# **Byron Unit 1 Extended Cycle 8 Report**

**ComEd**

**October 1996**

### **BYRON UNIT 1 RESPONSE TO**

Figure 30D

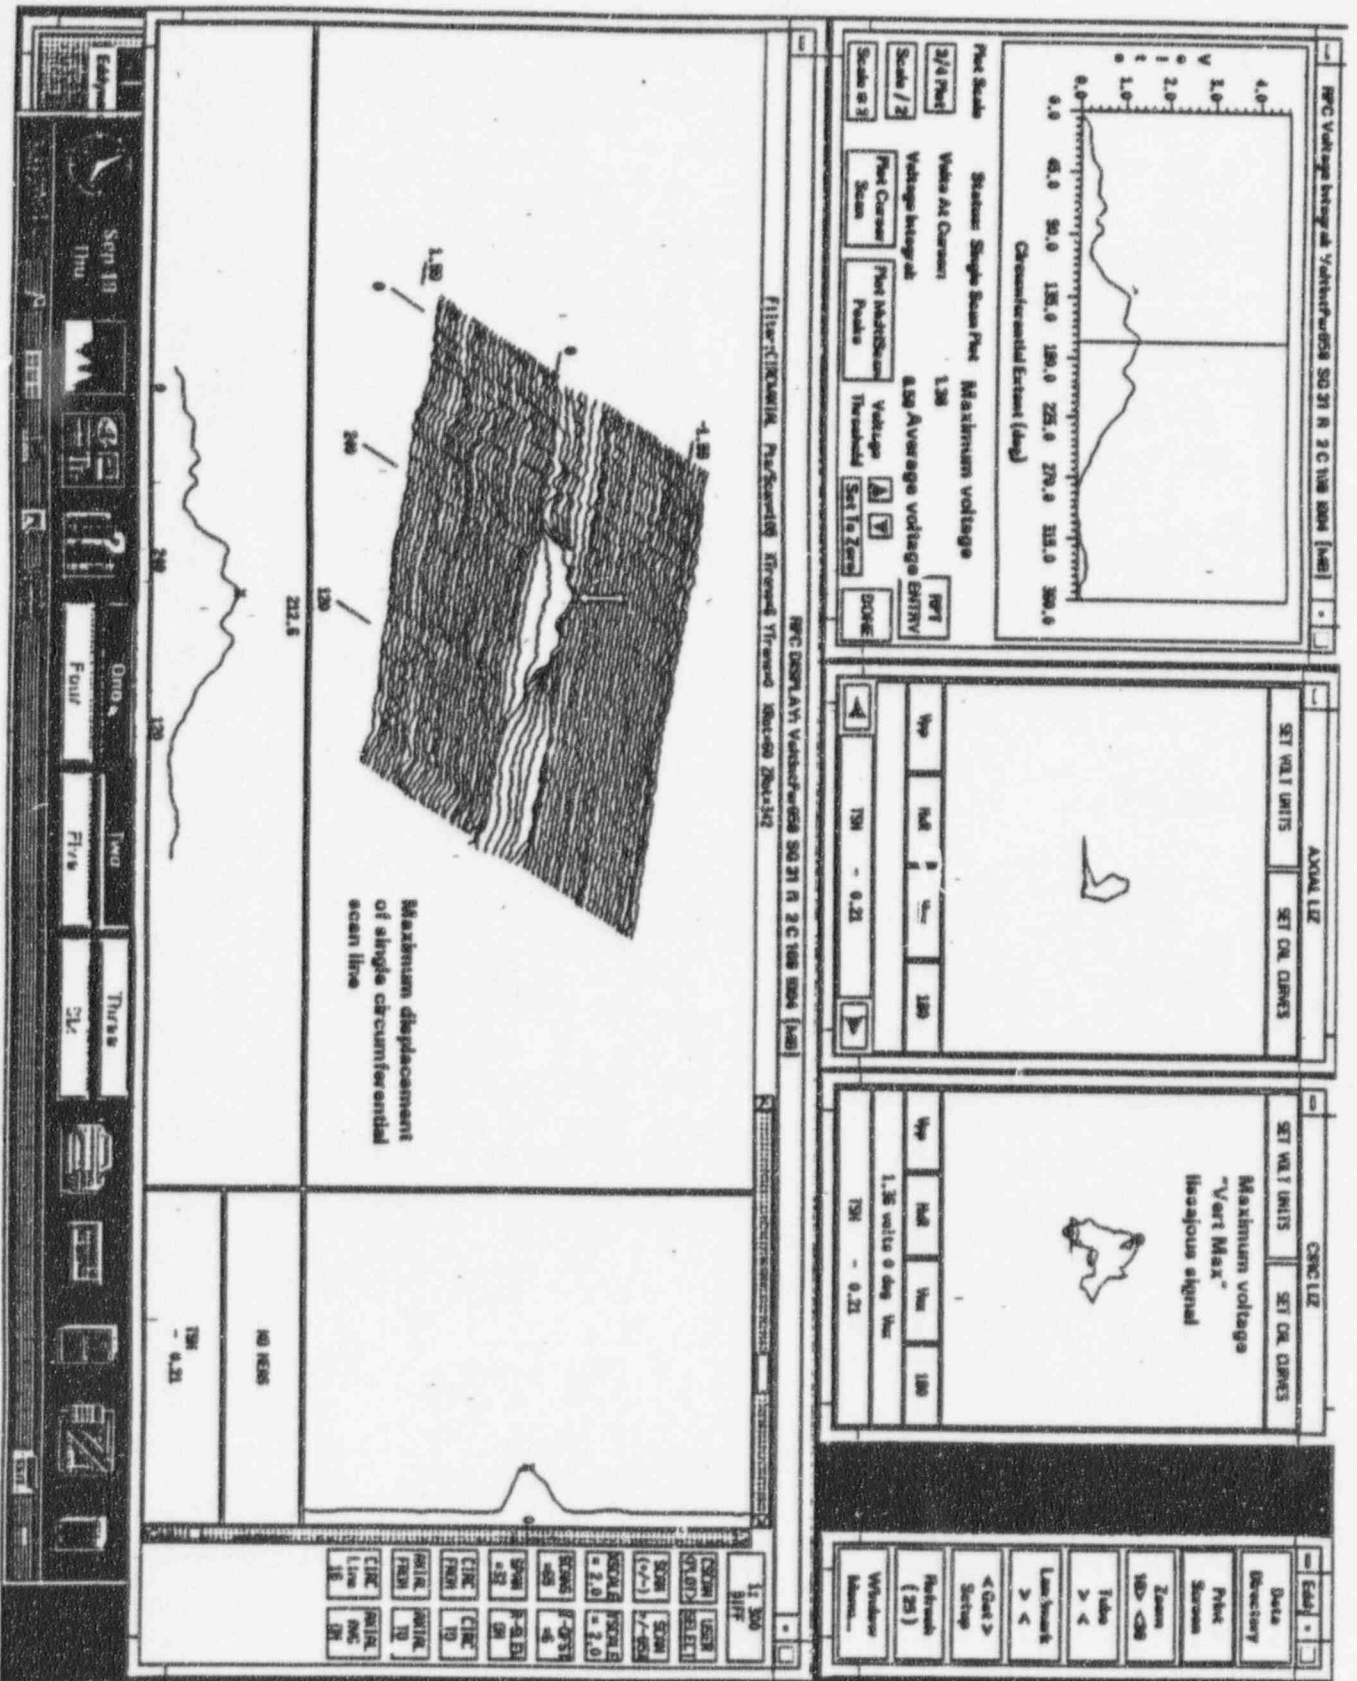
30. **Provide a copy of the EC sizing procedures used in the assessments of the analyst uncertainty, the growth rate, the burst and leakage data, and the POD. Discuss the extent of use and the influence of the following on any EC voltage measurements: (1) the use of Eddynet95 data filters; (2) the trigger offset feature and (3) the presence of 360m circumferential flaws. Address both the EC voltage integral and the EC maximum voltage measurements.**

To evaluate the impact of these filters and results, ComEd performed an evaluation on voltage measurements with the use of filters. Figure 30A represents voltage measurements for non-filtered data. Figure 30B represents voltage measurements with the use of the Axial Average filter. Figure 30C represents voltage measurements with the use of the Circ. Line filter. Figure 30D represents voltage measurements with the use of the Axial Average and Circ. Line filter.

- The maximum and average voltage does not change with an Axial Average filter.

- The maximum and average voltage does change with a Circ. Line filter. The resultant output of the voltage measurements is reduced. Selecting a non-degraded circ line to be used as a filter does not reduce the flaw signal.
- The maximum and average voltage remains the same as the Circ. Line filter, when using the Axial Average and Circ. Line filters in combination.

Therefore, ComEd analysis is correct because the use of filters does not affect the voltage signal corresponding to the flaw.

Figure 5a

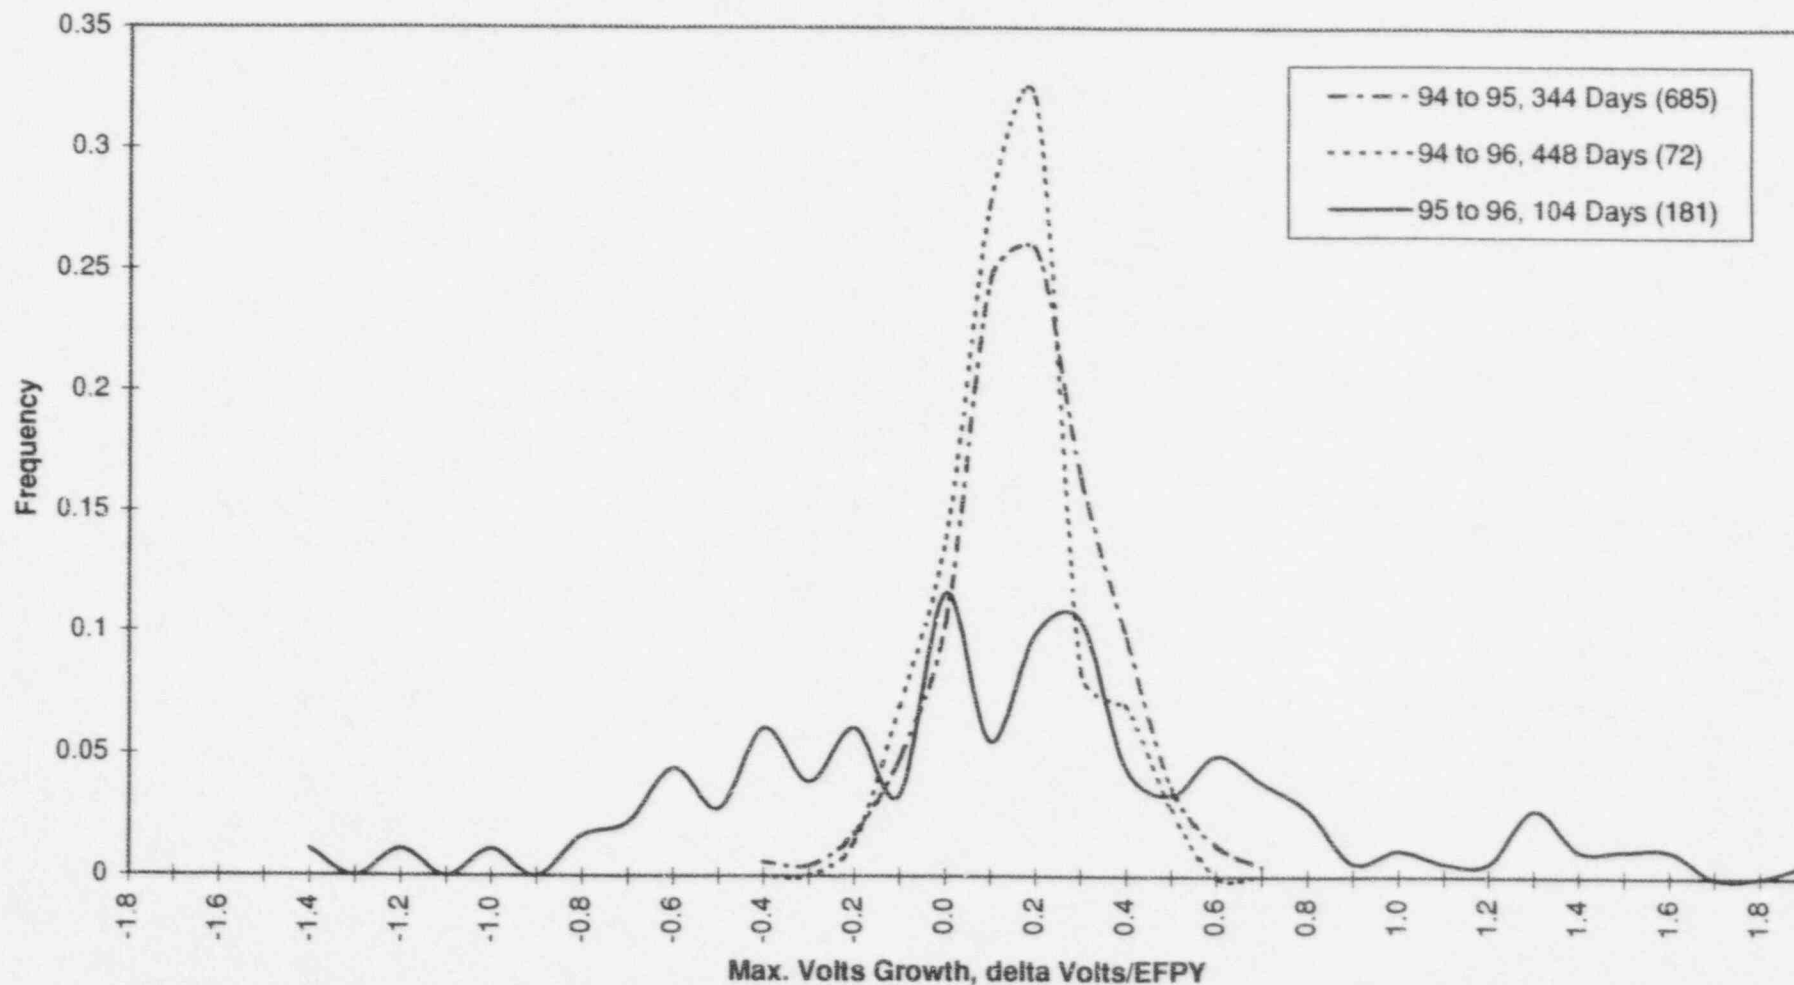
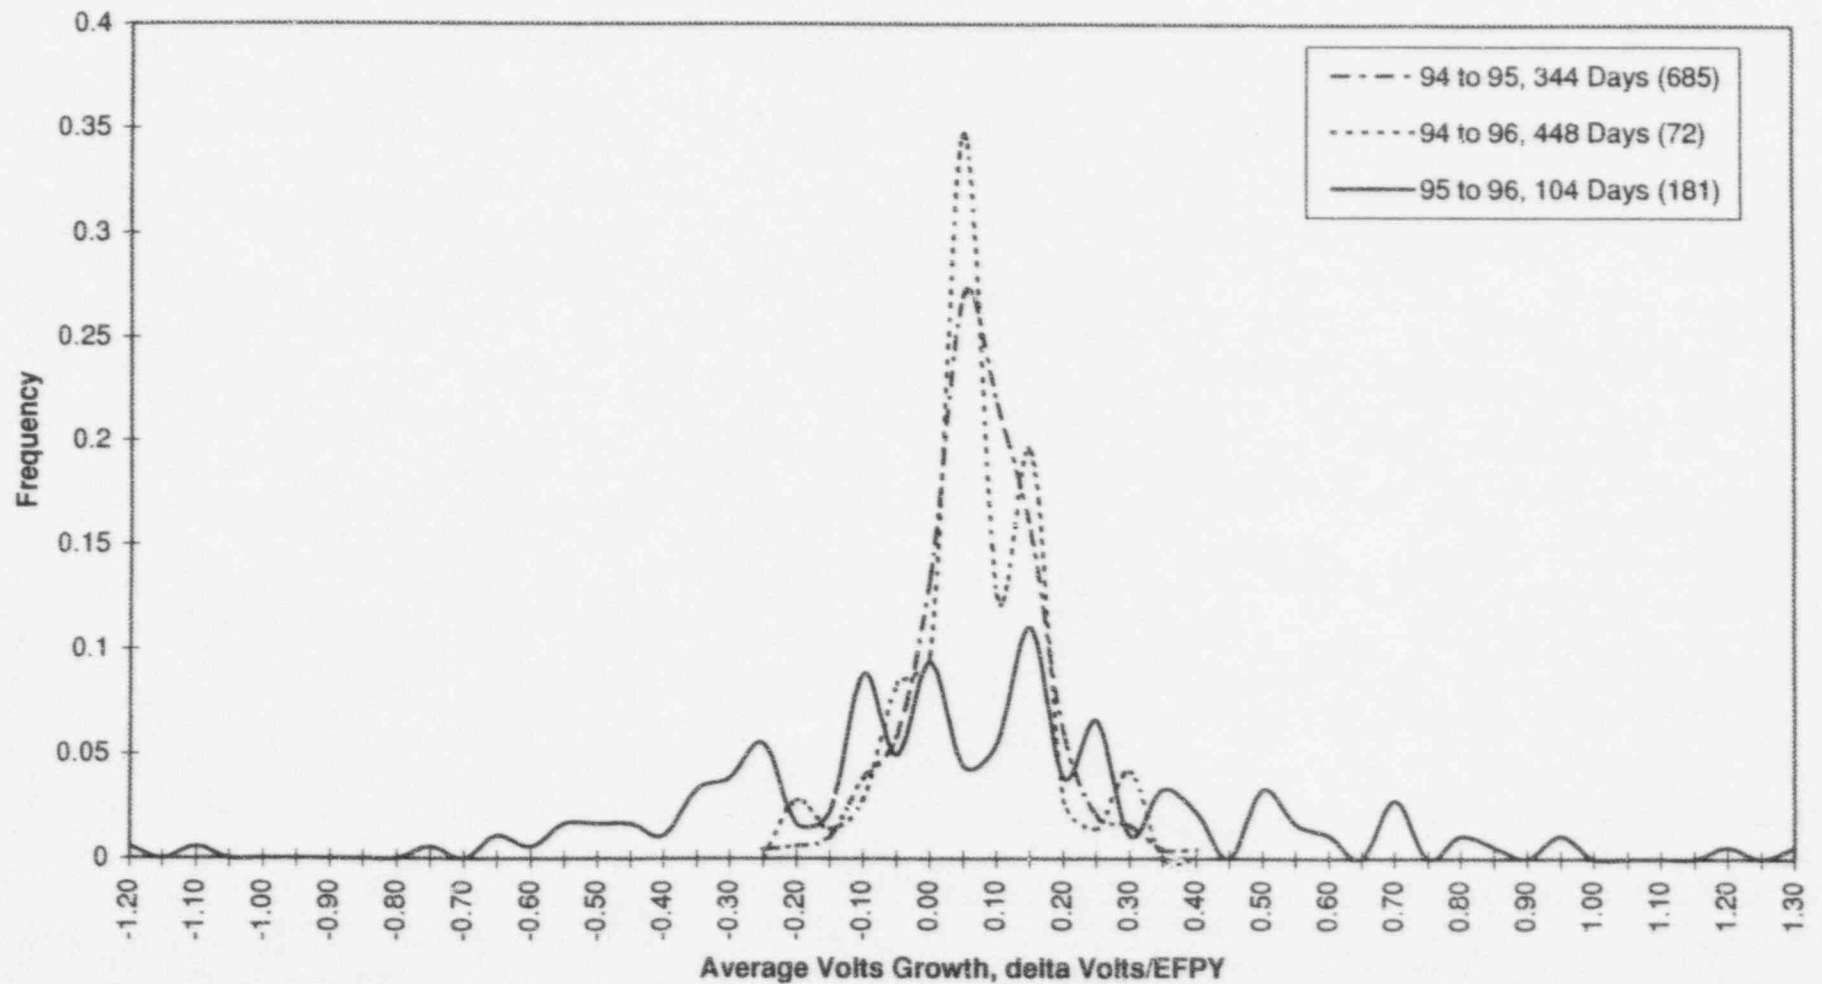
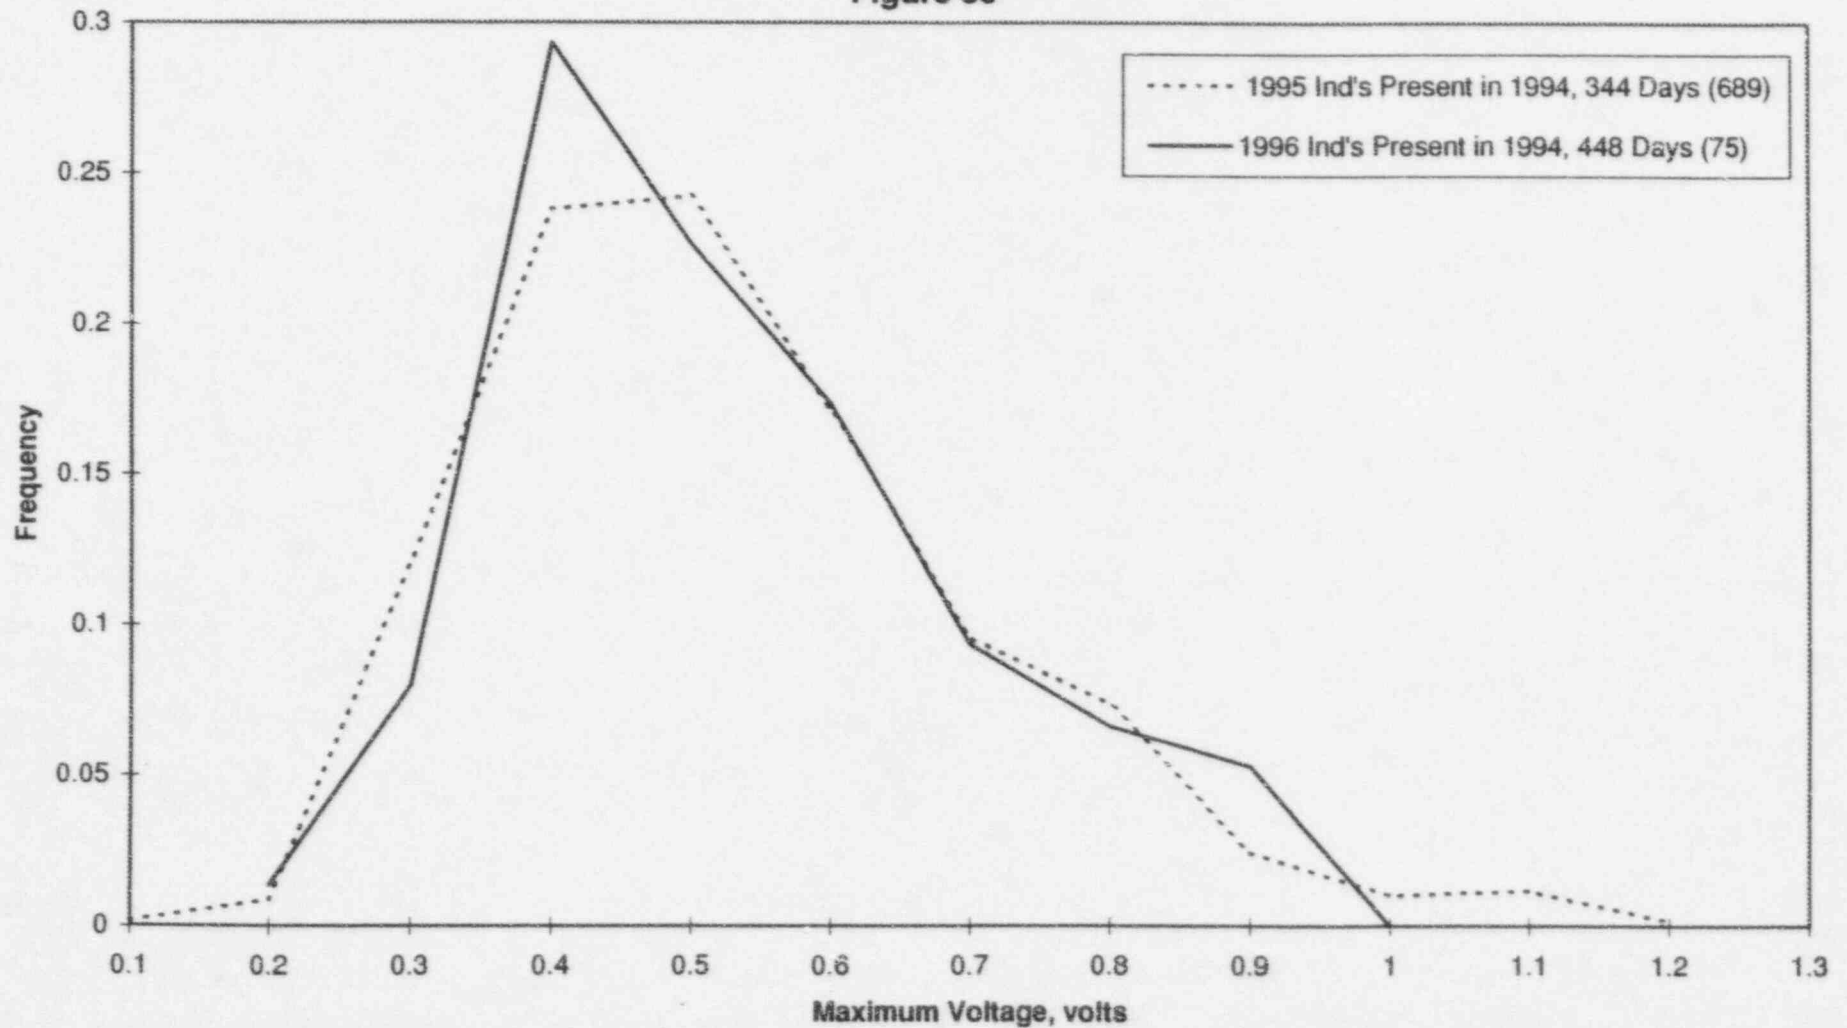
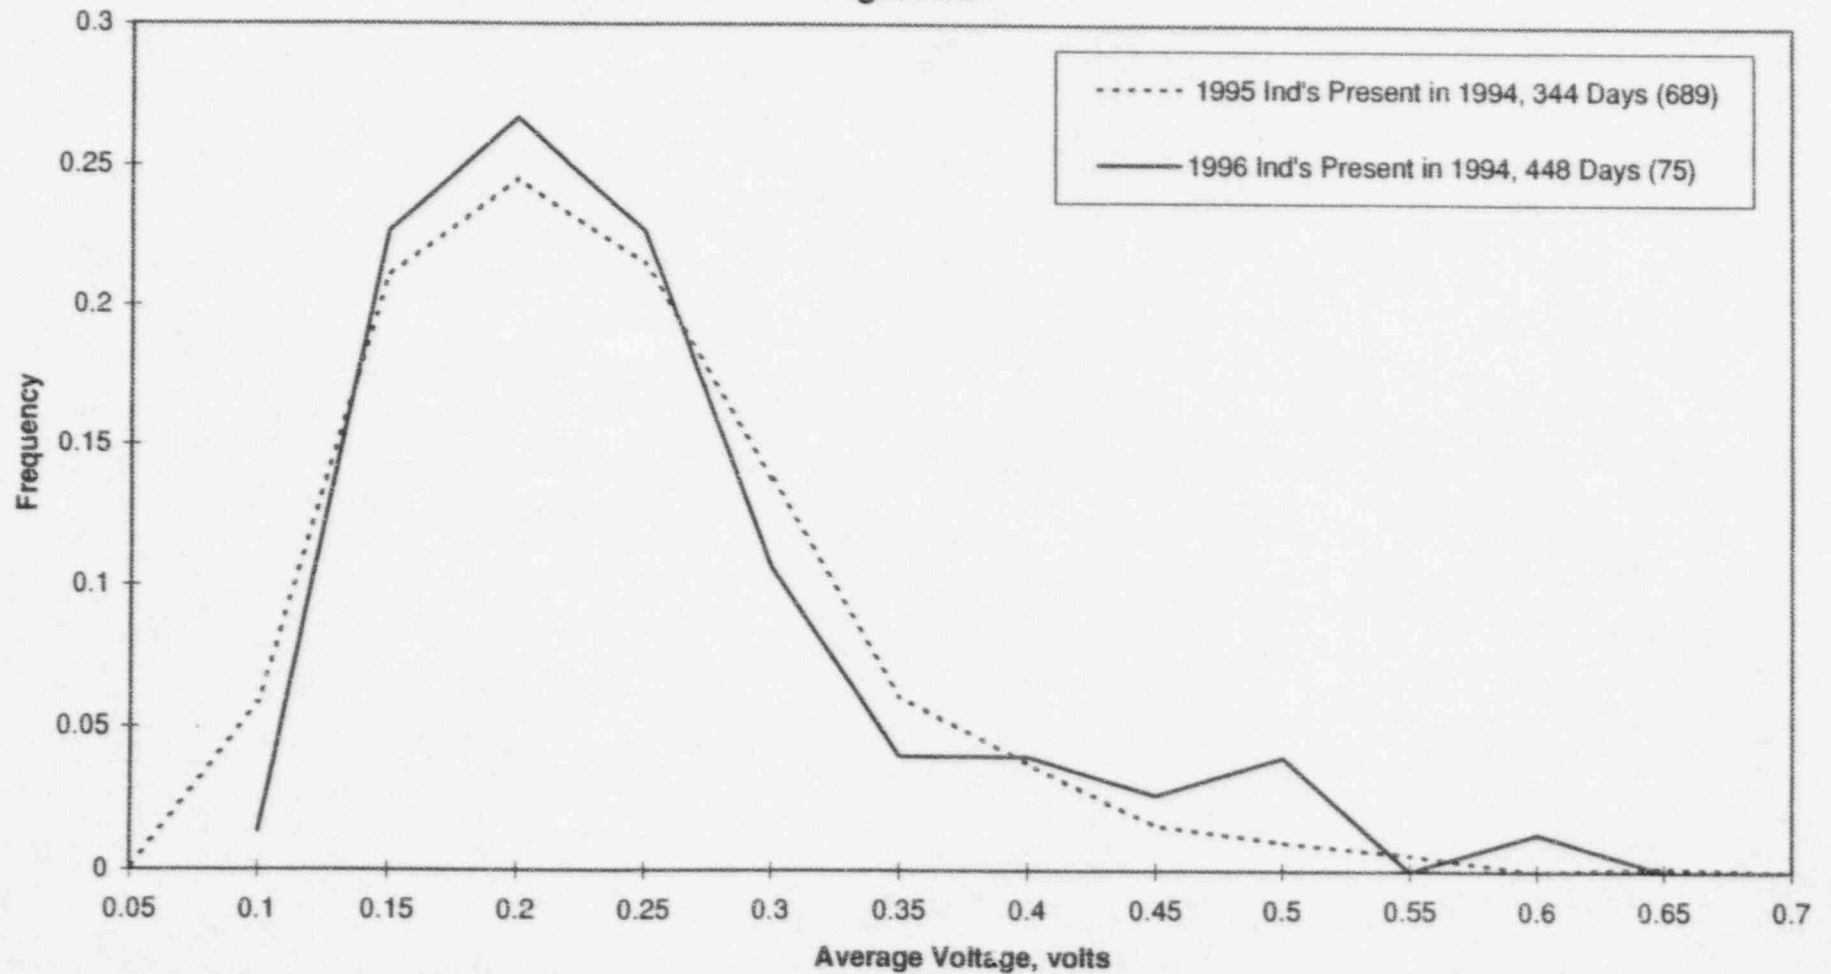
3. **The licensee's assessment of Byron Unit 1 growth rates considered inspection data from three inspection outages. Supply the growth rate data for each of the three intervals between these outages; i.e., the interval between the first and second SG tube inspections, the interval between the second and third inspection outages and the interval between the first and third inspection outages. Indicate which of the intervals exhibited the largest growth rate on an effective full power year (EFPY) basis. Provide these data in tabular form separated into the voltage bins shown in Figures 4.3 and 4.4 of your August 2, 1996, submittal. Explain how the indications were: placed in a particular bin. That is, state whether EC voltage values were truncated or rounded up to the higher voltage bin (e.g., 0.45 volts would be raised to 0.5 volts).**

An assessment was performed of Byron Unit 1 growth rates to determine the appropriate intervals to be used. Because full cycle operation is being evaluated, growth rates from as near a full cycle as possible were considered to minimize the uncertainty associated with short interval growth rates. Figure 5a and 5b presents the maximum and average growth rates for the three Byron Unit 1 intervals for which inspections sensitive to circumferential indications were performed (1994 to 1995, 1994 to 1996 and 1995 to 1996). The growth rates are for 0.080" RPC data normalized to 1 year of operation. The data was analyzed as a part of the 1996 voltage integral software look-back and includes indications repaired in 1995 and 1996.

The distribution of growth rates shown in Figures 5a and 5b provide the following observations: the growth rate distributions for longer intervals, approximately one full cycle of operation (1994 to 1995 and 1994 to 1996), are smooth with relatively short tails and is peaked at the middle. The distribution for the short operating interval, approximately one quarter of an operating cycle (1995 to 1996) is not smooth, has long tails in both directions and is flat. The curves on the figures show that there is a significant difference in the short and long cycle growth rates.

Because there are some large short interval growth rates, an evaluation of the voltage distribution of 1995 and 1996 indications present in 1994 was performed. If the large short interval growth rates were real it would be expected that the distribution of indications present from 1994 to 1996 would be significantly greater than the distribution of indications present from 1994 to 1995. Figures 5c and 5d show the Frequency of indications versus the maximum and average voltage in volts,
